AUXILIARY FEEDWATER SYSTEM
NO. 1 AND 2 UNITS
SALEM NUCLEAR GENERATING STATION
DOCKET NOS. 50-272 AND 50-311

Public Service Electric and Gas hereby submits additional information in response to your concerns regarding the Auxiliary Feedwater System. This information was requested at a meeting with members of your staff on June 18, 1980.

Additional Information
Auxiliary Feedwater System
No. 1 and 2 Units
Salem Nuclear Generating Station

FIGURE 1

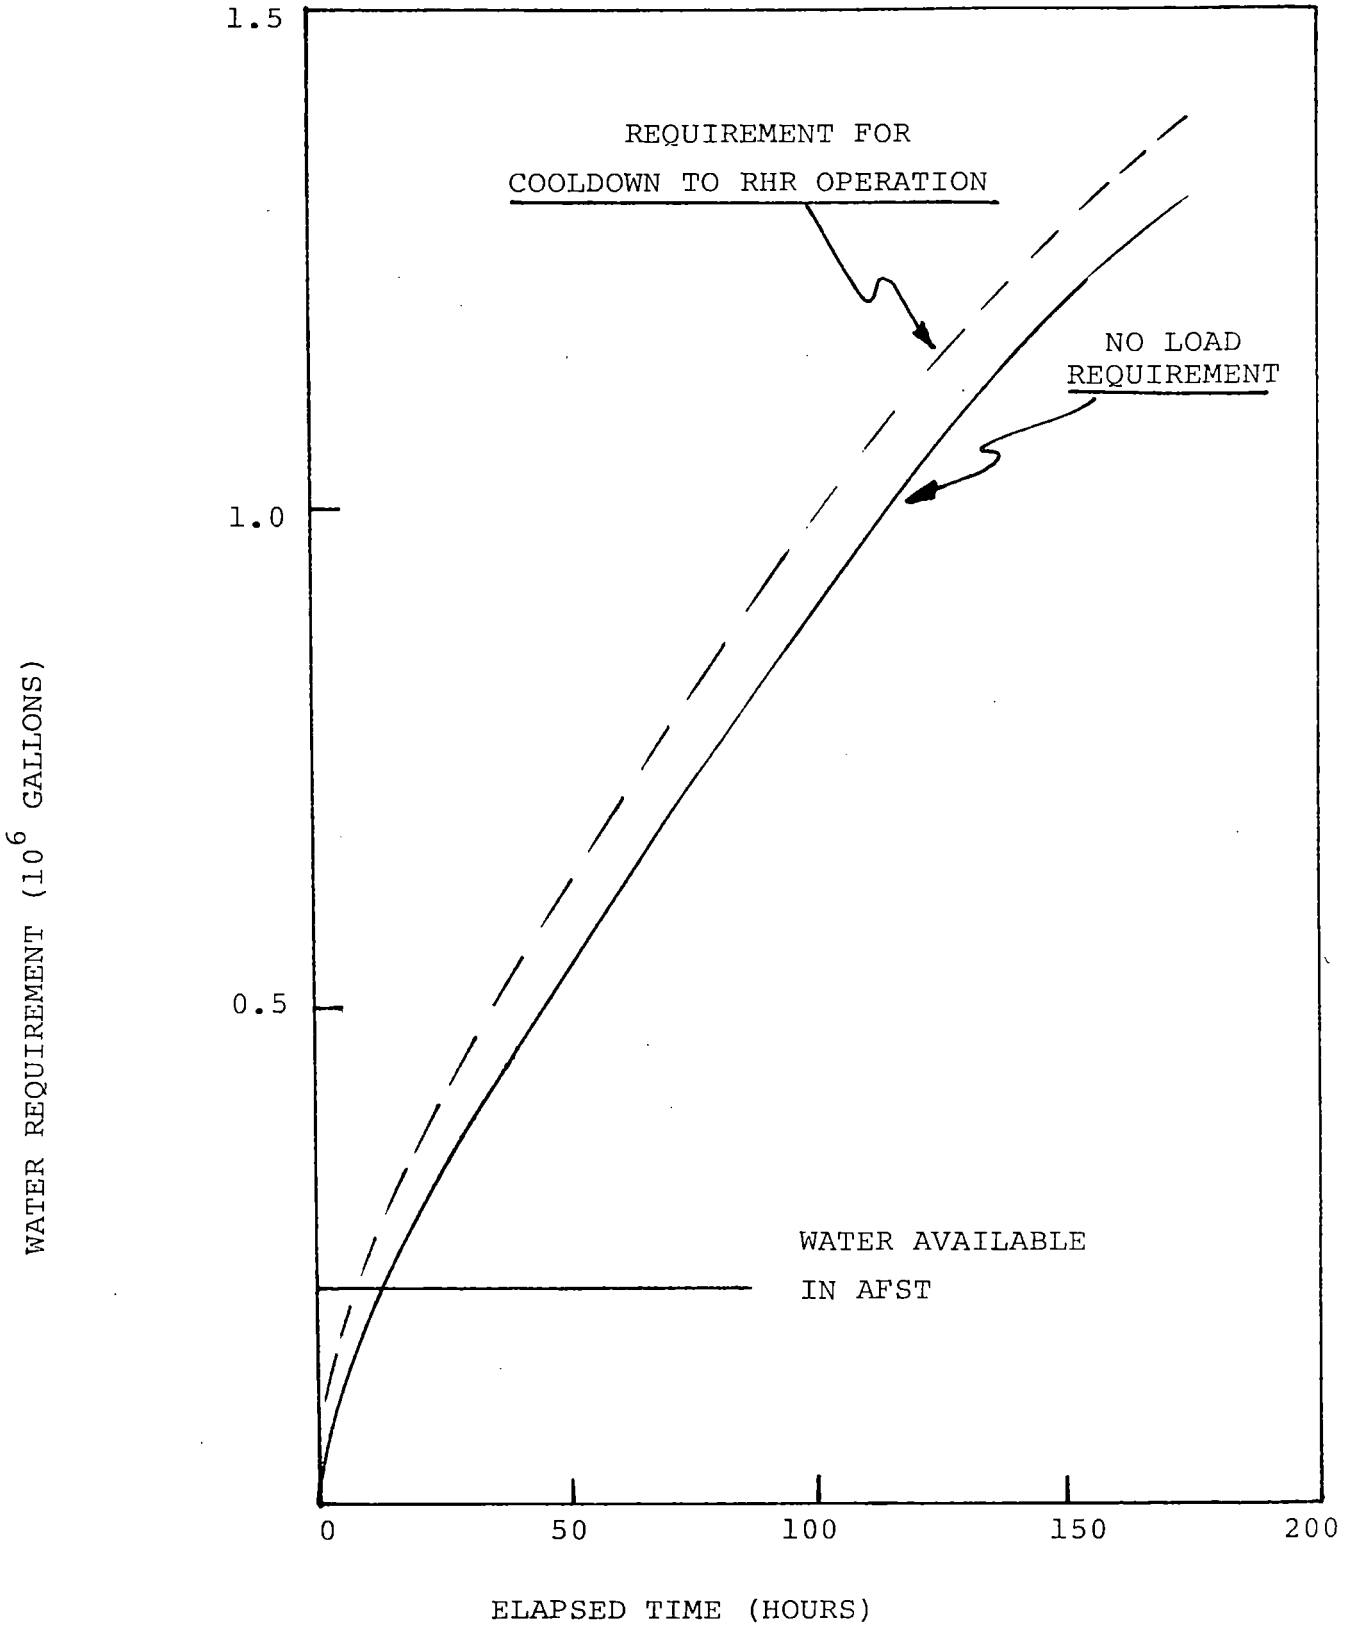
1. Salem 2 FSAR Amendment 43 addresses branch technical position RSB 5-1, Cold Shutdown Requirements. We note that the long-term auxiliary feedwater supply source (service water system) may contain salt in solution. Justify the salt content of this water (for the time period required to satisfy RSB 5-1) against the following considerations:
 - a. degradation of steam generator shell side heat transfer due to salt plating or tubes,
 - b. clogging of steam generator secondary side flow paths by clumps of accumulated salt,
 - c. corrosion effects of the salt.

Figure 1 shows that 0.602×10^6 gallons of water will be required to maintain the plant at the no load condition for 43 hours plus at least a 5 hour cooldown to begin RHR operation. 0.22×10^6 gallons of this water will be supplied from the AFST, and should not contribute significantly to the salt burden of the Steam Generators. Thus the salt water requirement to meet RHR operation within 48 hours is

$$(0.602 - 0.22) 10^6 \text{ gallons} \\ = 0.382 \times 10^6 \text{ gallons}$$
